**Subject:** A/YL-KTS/993 (Part 1)

TPB Ref.: A/YL-KTS/993

**Proposed Temporary Logistics Centre for a Period of 3 Years & Filling of Land at Lot 403 RP (Part) in D.D. 103 and Adjoining Government Land, Kam Tin, Yuen Long, New Territories**

**Response to Comments**

Figure 4

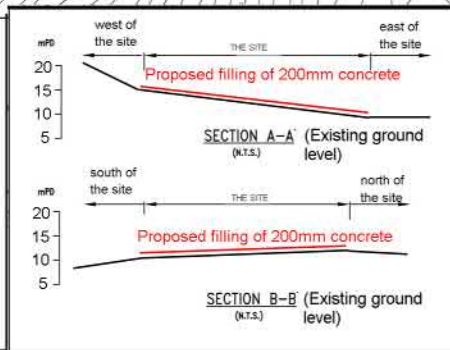
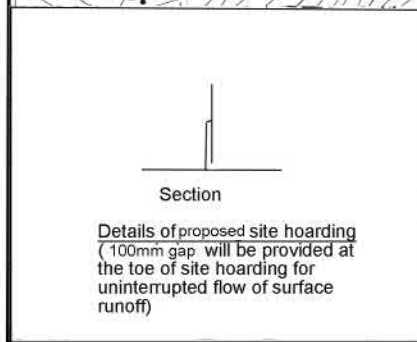
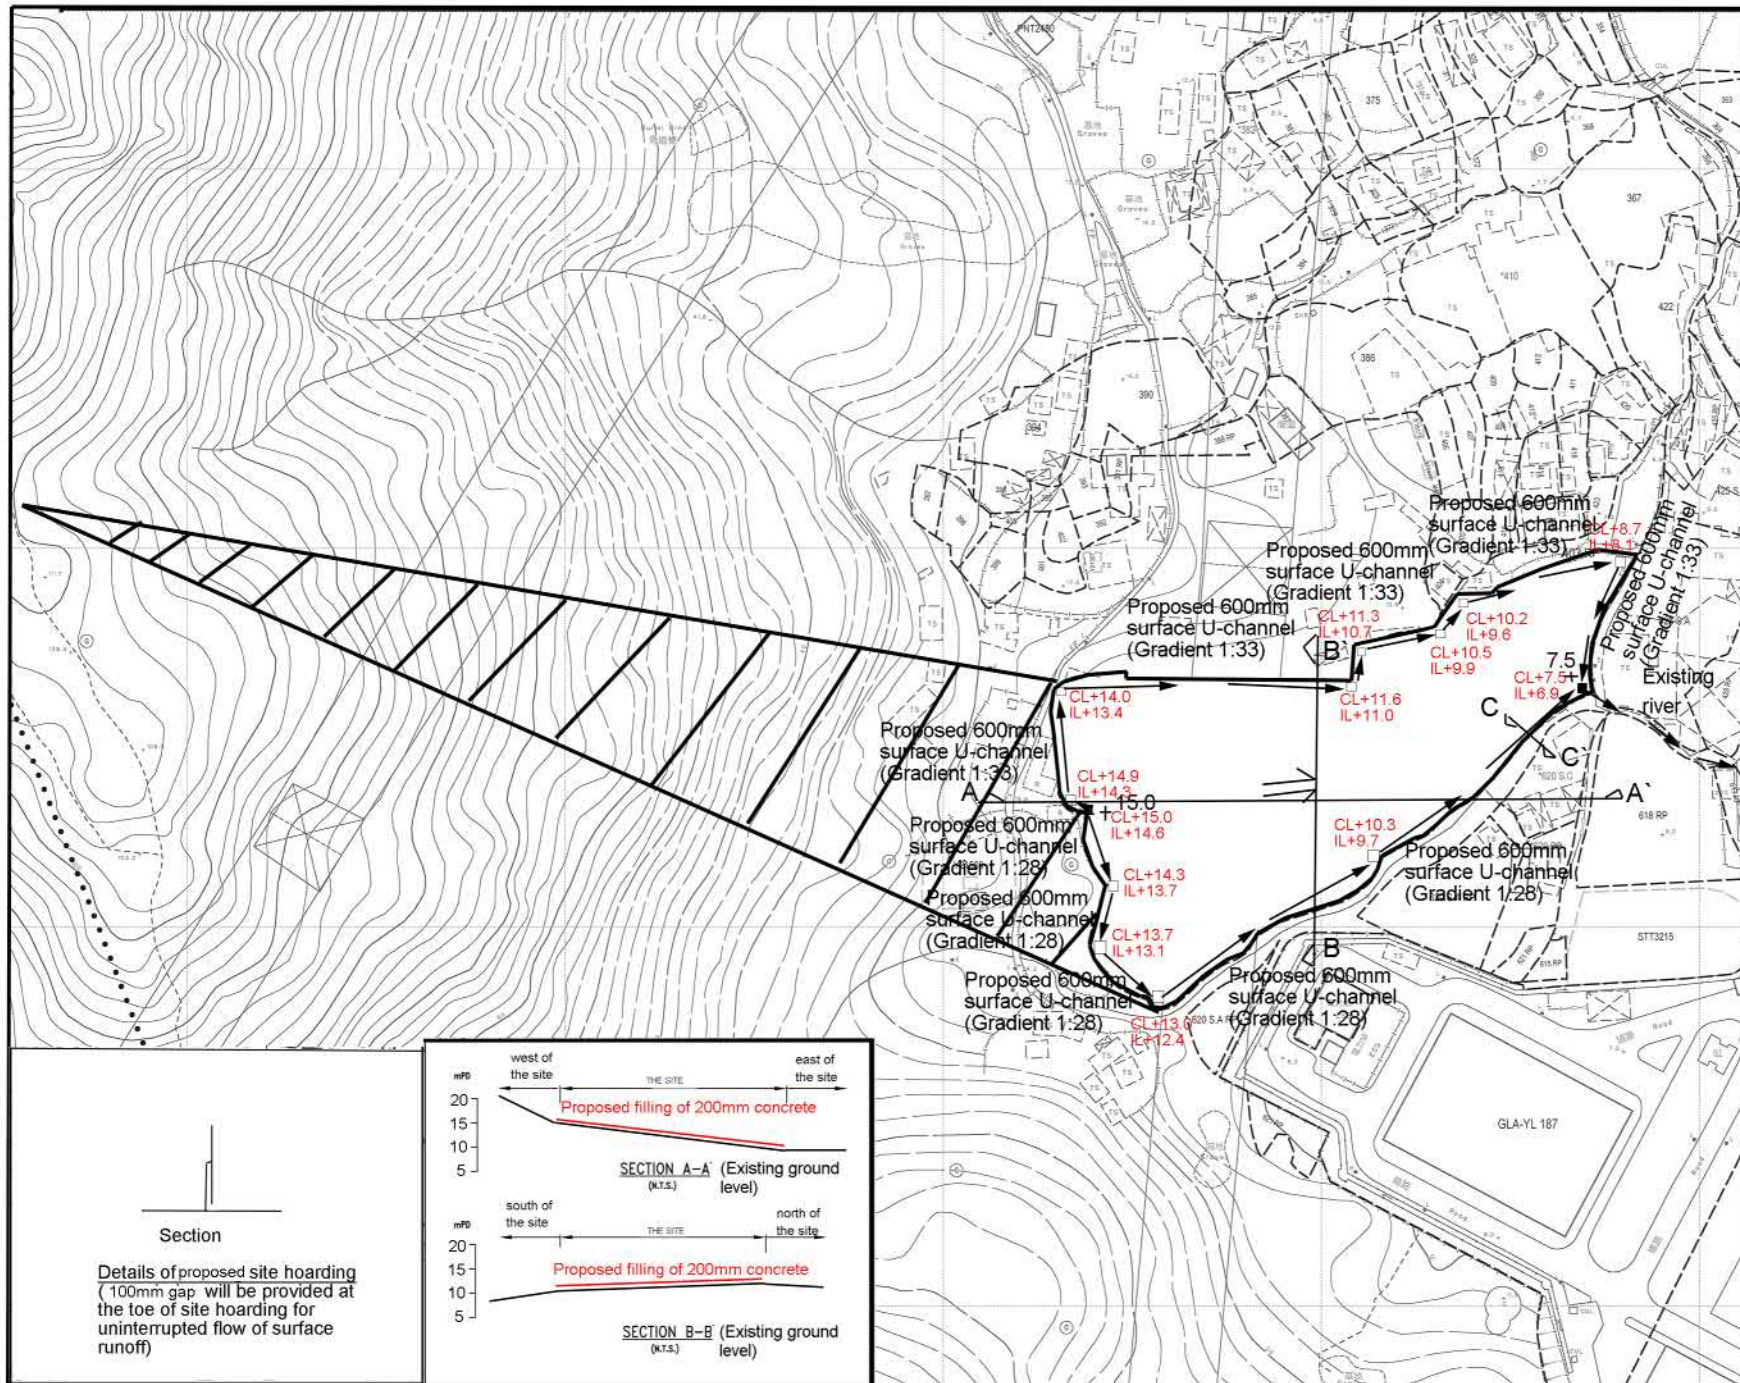
Comments of the CE/MN, DSD	Applicant's response
(i) It is noted that 9000m <sup>2</sup> of land to be filled as mentioned in the planning application and shown in Figure 5. However, according to section 1.3.7 (c) of the submitted drainage proposal, it is stated that no levelling works will be carried out at the site periphery. Cross sections showing the existing and proposed ground levels of the captioned site with respect to the adjacent areas should be given. Please be reminded that the development should neither obstruct overland flow nor adversely affect existing natural streams, village drains, ditches and the adjacent areas, etc.	Noted. The applicant confirms that 200mm thick concrete will be paved for the proposed development. There is typo in the section 1.3.7 (c) of the submitted drainage proposal. The cross section showing the existing and proposed ground levels of the captioned site with respect to the adjacent areas is shown on the updated drainage plan. The development would neither obstruct overland flow nor adversely affect existing natural streams, village drains, ditches and the adjacent areas, etc.

(ii) Please provide site photos to demonstrate that there is an existing open drain at the southern side of the site to intercept the overland flow from the adjacent lands. Otherwise, the ground to the south of the application site is significantly higher, external catchment shall be	Noted. Please see photo 1 below.

<p>considered in the calculation.</p> <p>(iii) The existing watercourse, to which the applicant proposed to discharge the stormwater from the subject site was not maintained by this office. The applicant should demonstrate that the proposed drainage construction/improvement /modification works and its operation of the drainage can be practicably implemented on site. In the case that it is a local drains, DO/YL should be consulted.</p> <p>(iv) Further to (iii) above, there is no record of the said discharge path, please provide site photos to demonstrate its presence and existing condition.</p> <p>(v) The applicant should check and ensure the hydraulic capacity of the existing drainage facilities would not be adversely affected by the captioned development.</p> <p>(vi) The cover levels and invert levels of the proposed u-channels, catchpits/sand trap should be shown on the discharge plan.</p> <p>(vii) Please provide the details of the proposed 100mm gap at the toe of the site hoardings on the drainage plan for comment.</p> <p>(viii) The applicant should consult DLO/YL and demonstrate that the proposed drainage construction/improvement/ modification works and the operation of the drainage outside his lot boundary can be practicably implemented on site.</p>	<p>Noted. The applicant is the tenant of the application site so that he has the full control on the construction of the drainage facilities within on the private land. He will liaise with DLO/YL for the provision of drainage facilities at the adjoining Government land such as renting the land under short term tenancy. In the case that it is a local drains, DO/YL would be consulted.</p> <p>Noted. Please see photo 2.</p> <p>Noted and confirmed in the calculation. The existing river is much wider than 600mm so that it would be adequate to cater for the additional stormwater from the subject site.</p> <p>Noted and please see the updated drainage plan.</p> <p>Noted and please see the updated drainage plan.</p> <p>Noted. The applicant will liaise with DLO/YL for the provision of drainage facilities at the adjoining Government land such as renting the land under short term tenancy.</p>

DRAWING NO.	<b>FIGURE R1</b>	REV.	.
<b>LLA 顧問有限公司</b>		<b>Consultancy Limited</b>

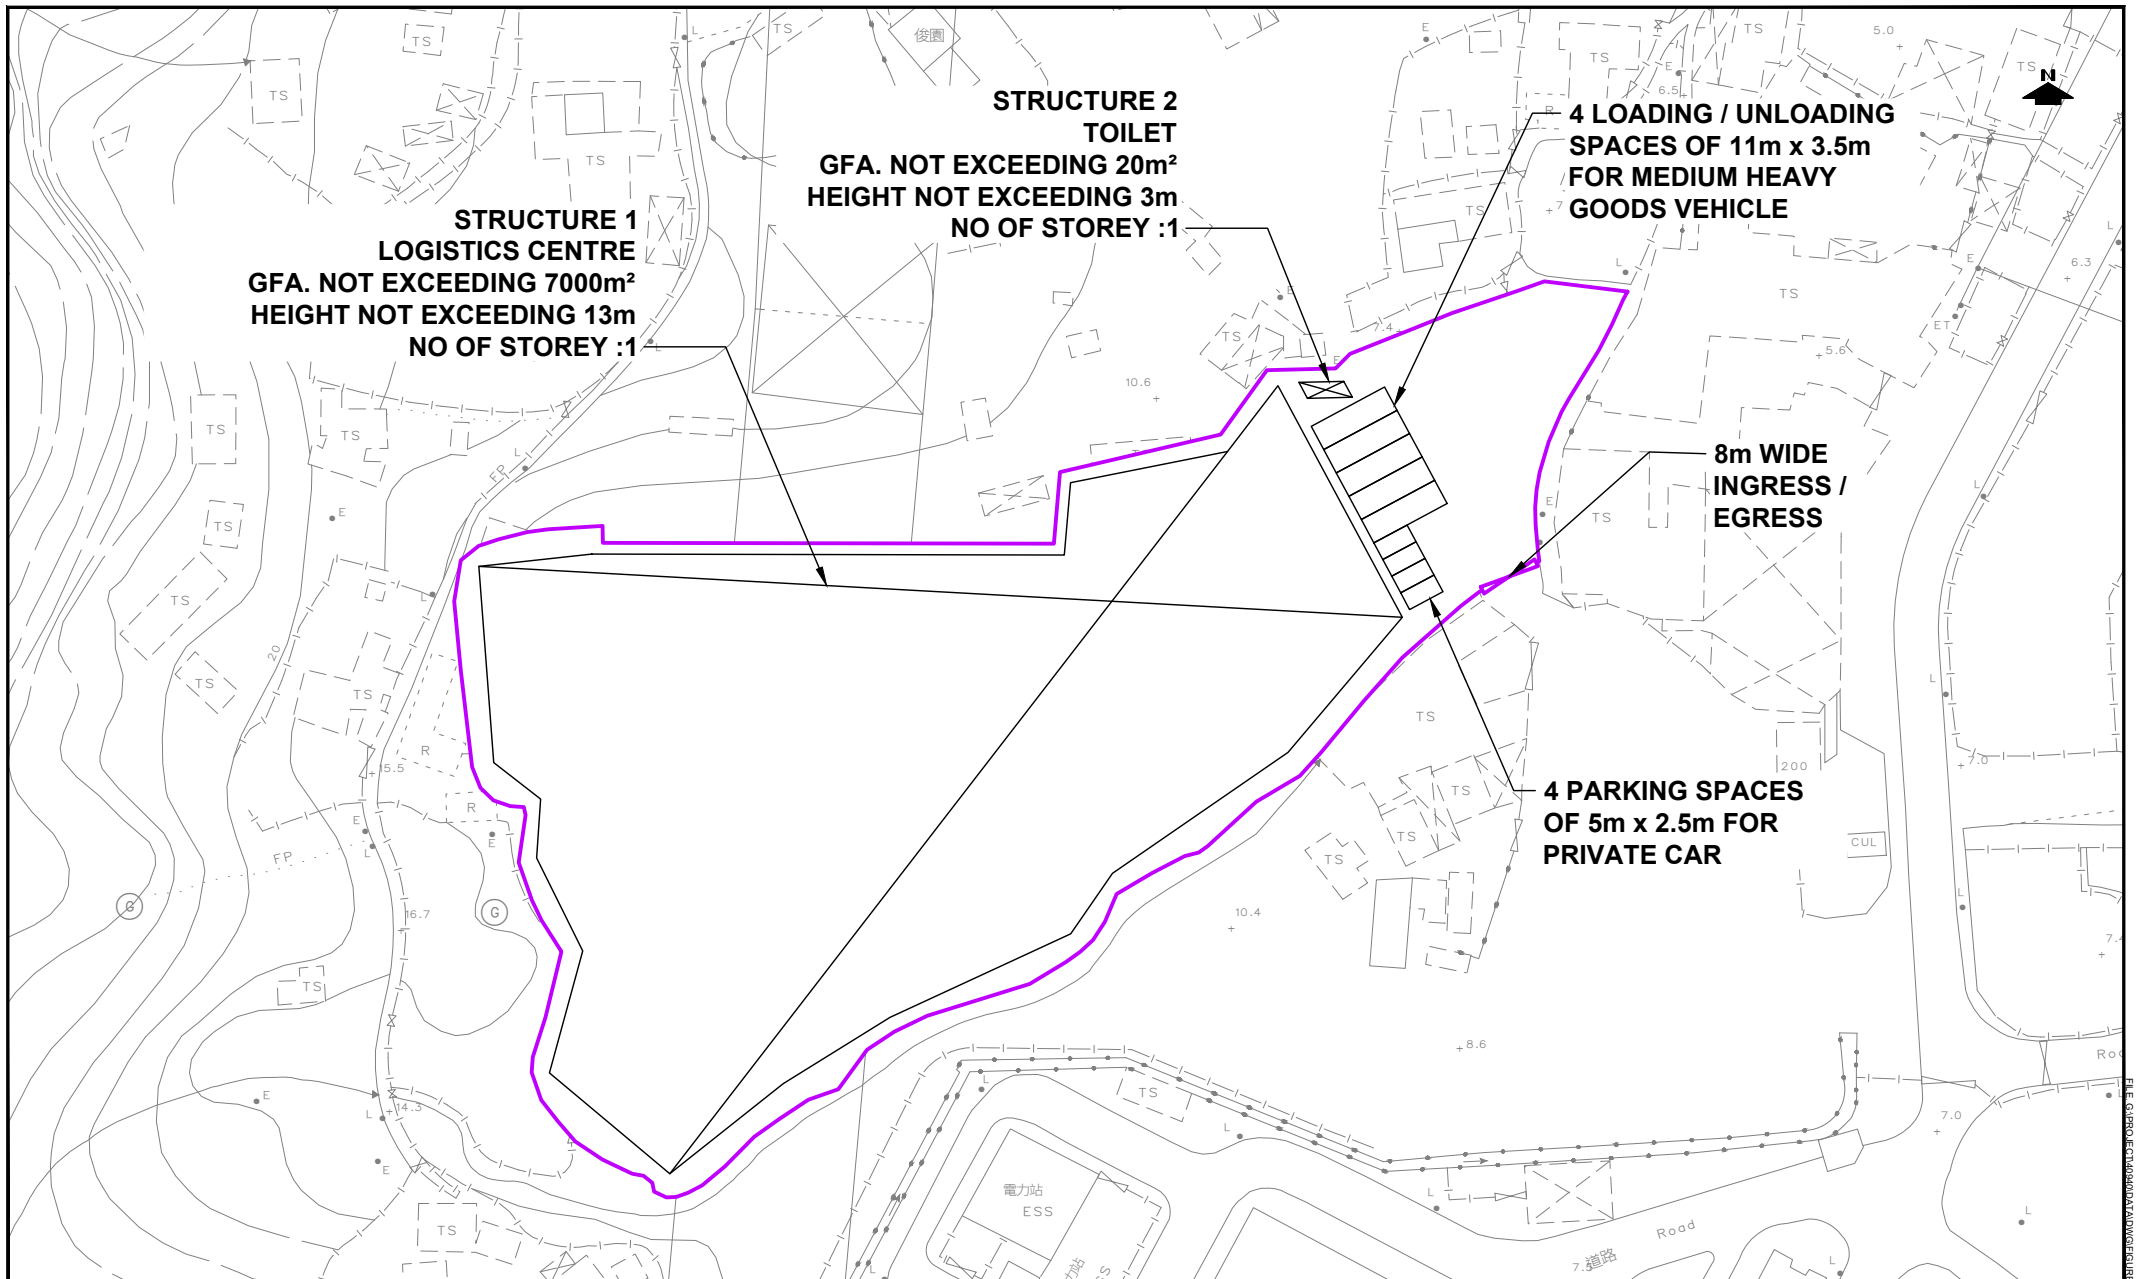
Comments	Responses												
Comments from Transport Department via Planning Department													
1. The applicant should provide the trip generation and attraction due to the development and assess the traffic impact to Kam Tin Road and the local access;	<p>According to the applicant the proposed temporary logistics centre will generate and attract at most 4 heavy goods vehicles and 4 private cars in an hour which is equivalent to 14 pcu/hr (by adopting a pcu factor of 1 to private car and 2.5 to heavy goods vehicle).</p> <p>For conservative assessment purpose, it is assumed these traffic will arrive and leave within the same hour, therefore, the proposed temporary logistics centre will generate and attract a two-way traffic of 28 pcu/hr during peak hours and adopted in the subsequent assessment.</p> <p>Traffic count survey is conducted at the concerned junction in the vicinity on 31 May 2024 during the AM and PM peak hours. The result of junction capacity assessment is shown below. The junction calculation sheets are also attached for easy reference.</p> <p><b>Existing Junction Capacity Assessment at J/O Kam Tin Road / Local Access Road</b></p>

<p>Note: (1) DFC = Design Flow to Capacity ratio for priority junction.</p> <p>The results show that the concerned junction is operating with spare capacity during both AM and PM peak hours after accommodating the traffic induced by the proposed temporary logistics centre.</p>	Scenario	Type/ Capacity Index <sup>(1)</sup>	AM Peak	PM Peak	<b>Without</b> proposed temporary logistics centre	Priority/DFC	0.16	0.23	<b>With</b> proposed temporary logistics centre	Priority/DFC	0.21	0.31
Scenario	Type/ Capacity Index <sup>(1)</sup>	AM Peak	PM Peak										
<b>Without</b> proposed temporary logistics centre	Priority/DFC	0.16	0.23										
<b>With</b> proposed temporary logistics centre	Priority/DFC	0.21	0.31										
2. The applicant should demonstrate the smooth manoeuvring of vehicles to / from Kam Tin Road along the local access and within the site;	Noted. Swept path analysis is conducted to demonstrate the manoeuvring of vehicles to / from Kam Tin Road along the local access and within the site. Please refer to attached <b>Figures SP-01</b> for details.												
3. The applicant should indicate the clear width of the vehicular ingress/egress on the layout plan;	Noted. Please refer to the attached <b>Figure R1</b> .												
4. The application should provide the routing between Kam Tin Road and the site;	Noted. Please refer to the attached <b>Figure R2</b> .

PROJECT NO.	DRAWING NO.	REV.
	<b>FIGURE R3</b>	.
<b>LLA</b> 顧問有限公司 Consultancy Limited

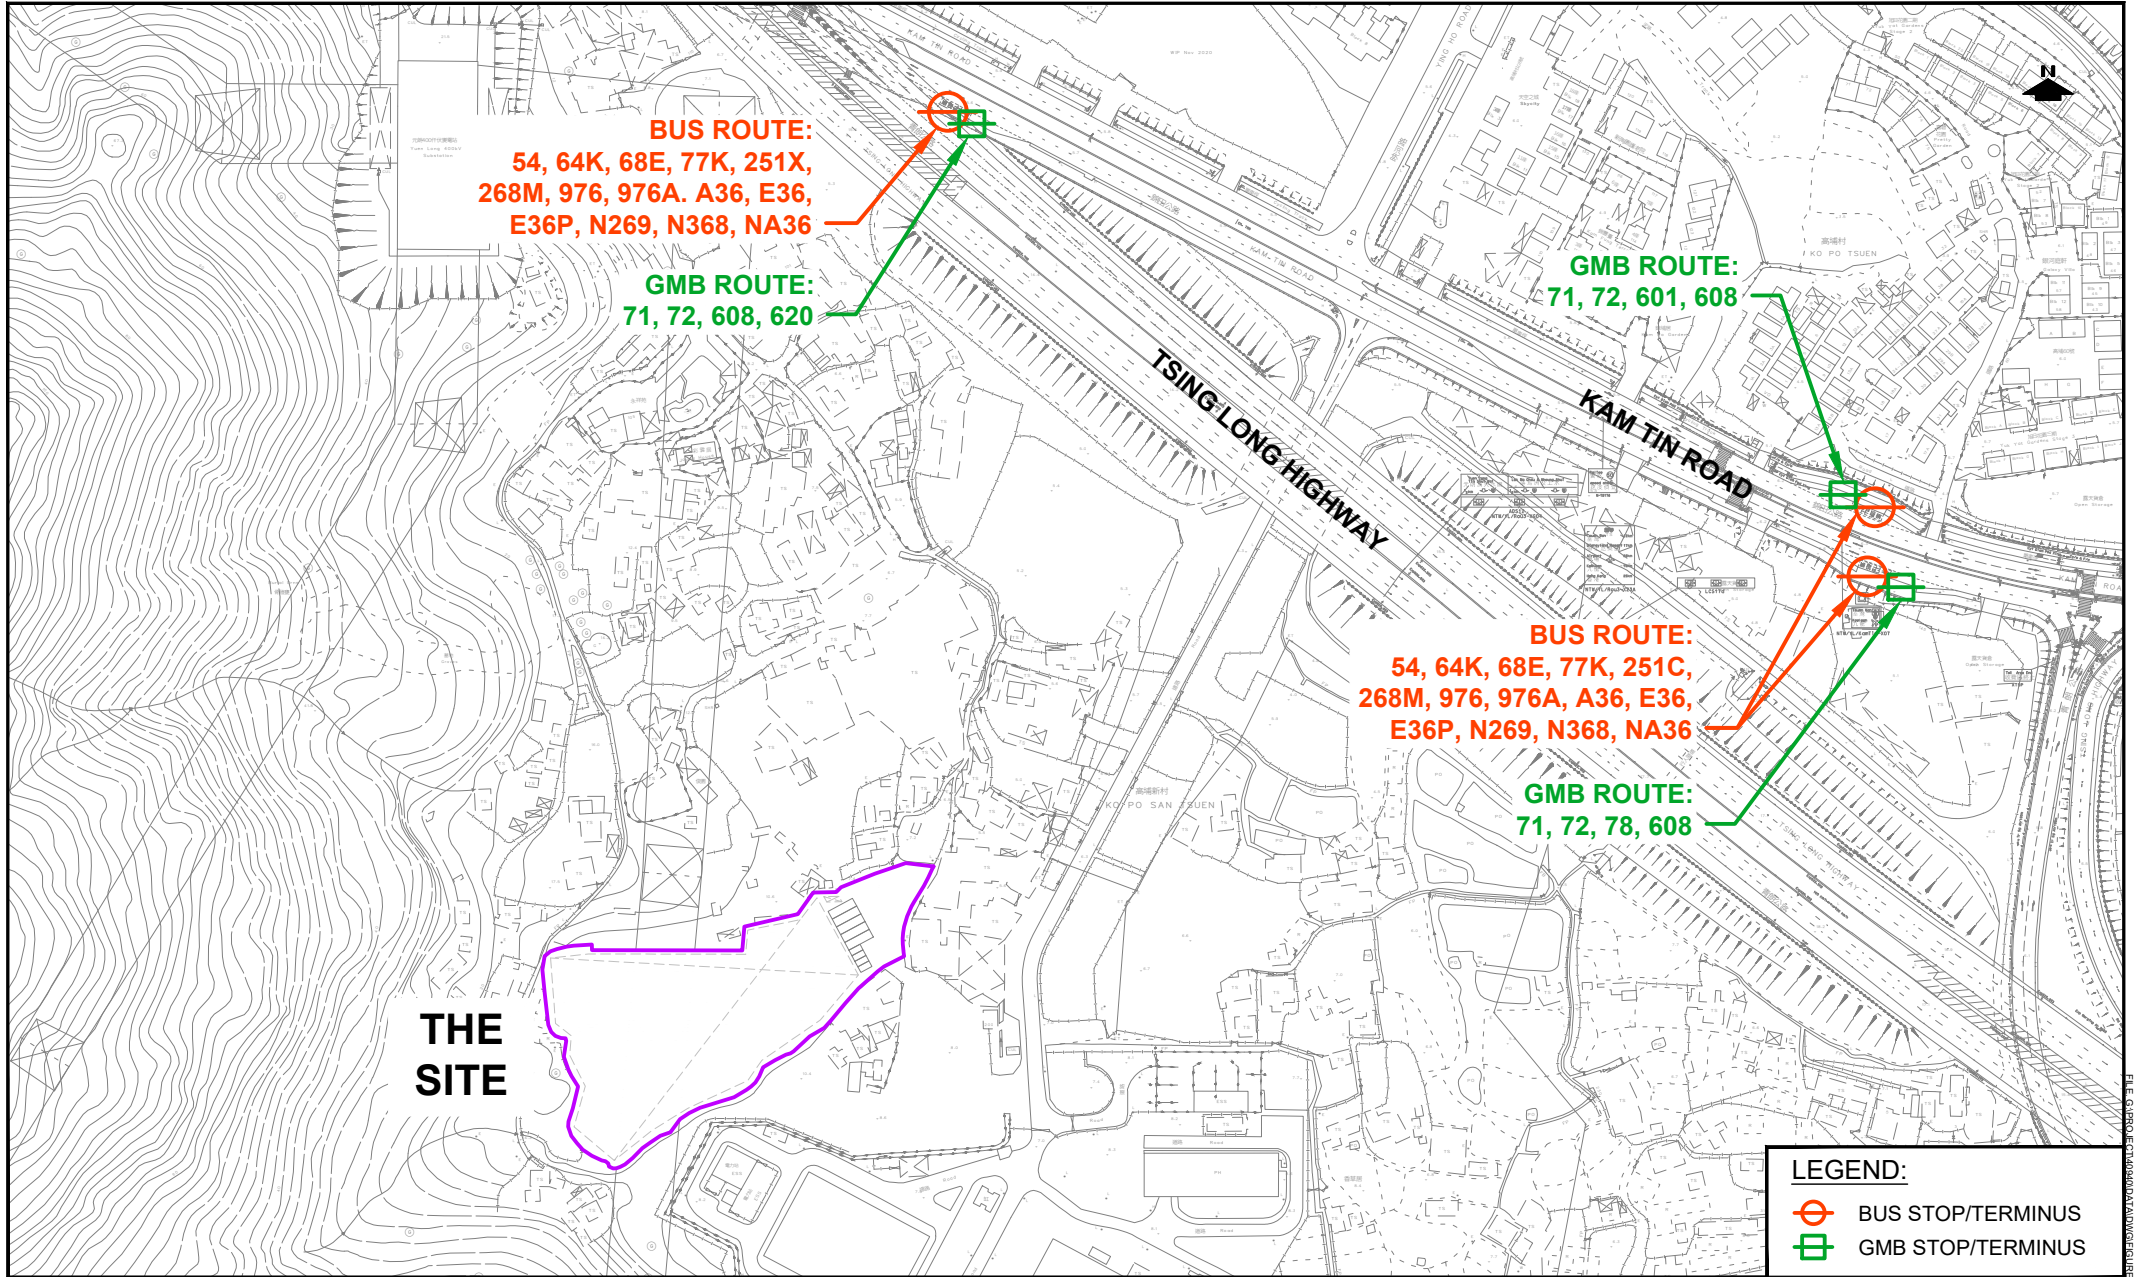
Comments	Responses
5. The applicant should provide nearest public transport services and indicate on the layout plan;	Noted. Please refer to the attached <b>Figure R3</b> .
6. The applicant should note the local access between Kam Tin Road and the site is not managed by this Department.	Noted.
